REMARKS

AMENDMENTS TO THE DRAWINGS

PROPOSED REPLACEMENT PAGE

Fig. 10

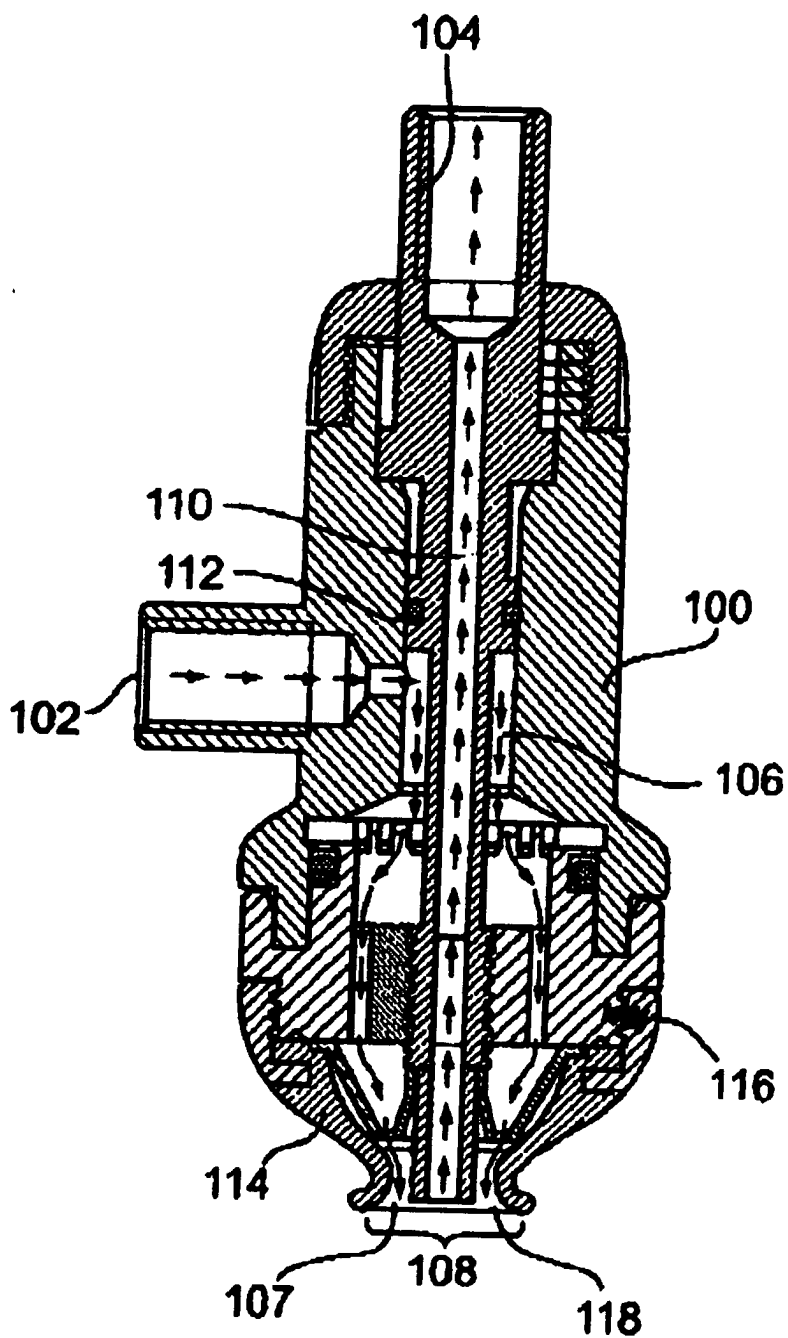
Applicant submits herewith a Proposed Replacement Page for the Examiner's review and approval. This is submitted to correct Fig. 10 of the drawings as shown in red ink. This correction is being made to correct the lead line from reference numeral "116". As it is believed that this correction will be approved, a formal drawing Replacement Page for Fig. 10 embodying this correction is also enclosed.
